**Presentation from  
Paul Sedran, RESD Inc.**

Application to extend the operation of  
Pickering Nuclear Generating Station  
Units 5 to 8 until December 31, 2026

# Review of Public Hearing Submissions on the Operation of the Pickering Nuclear Generating Station to 2026

CT ID Profiles from the Gauging Measurements of  
The CT Removed from Fuel Channel P4M11

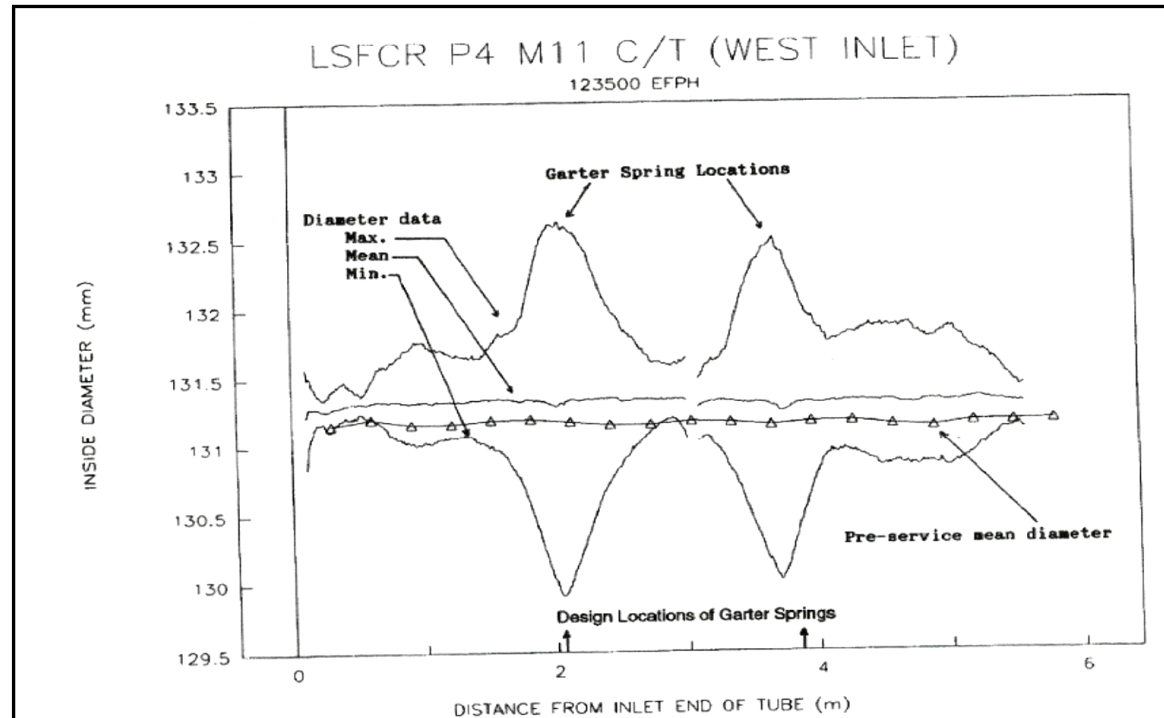
$$\text{CT ID} = 131.2 - 0.0105 t$$

where CT ID is in mm and  $t$  is the time in-service in kEFPH.

#### Inner Diameter Profile of a Pressure Tube From PNGS

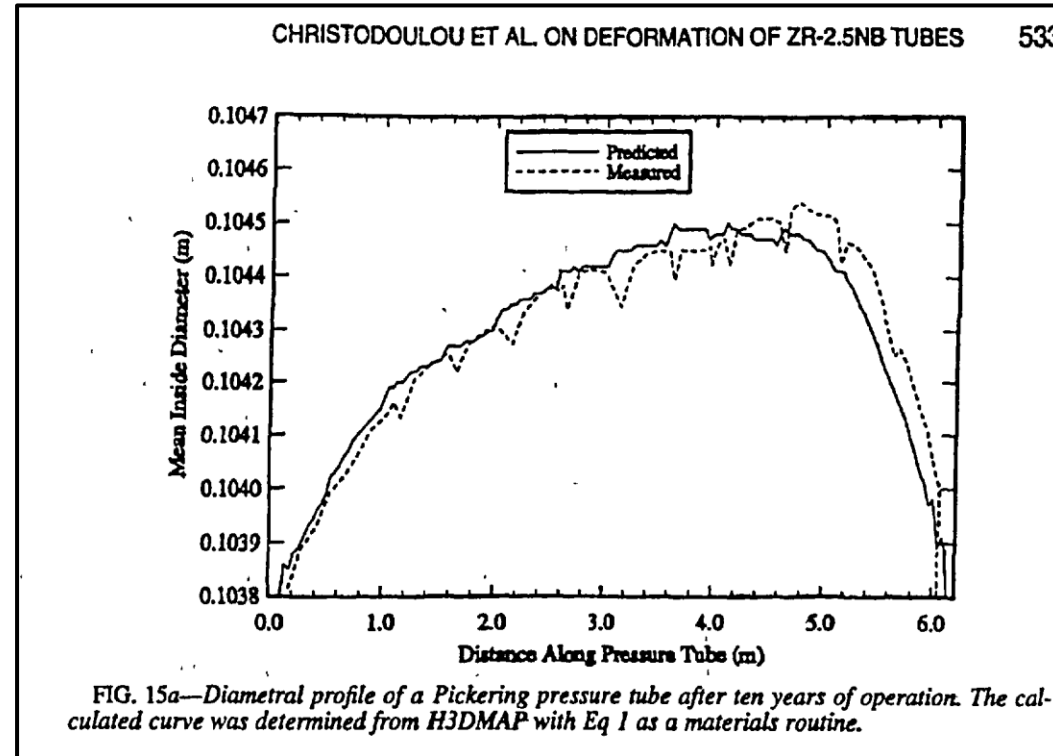
$$\text{Spacer OD} = 121.6 + 0.007 t$$

where Spacer OD is in mm and  $t$  is the time in-service in kEFPH.

## 2.3 Onset of Partial Nip-Up

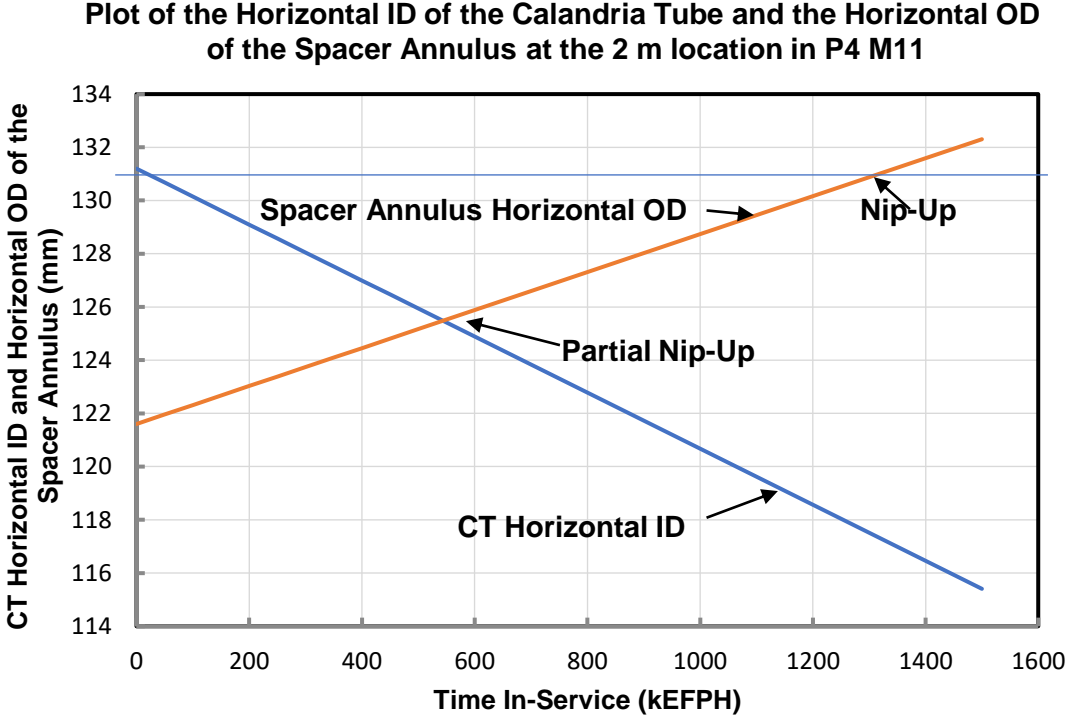
1. Based on an independent review, the author concurs that the PNGS Fuel Channels are fit-for-service for operation to the end of 2026.
2. With ovalisation of the CT at spacer locations, with time in-service, Partial Nip-Up of the spacer and CT will occur earlier than Nip-Up, but is not expected to be an issue for Fuel Channel fitness-for-service.
3. The Partial Nip-Up condition is not in the Pickering Fuel Channel Stress Report, but, CT stresses during Nip-Up, from a detailed finite element Nip-Up simulation, are expected to bound the stresses from Partial Nip-Up.
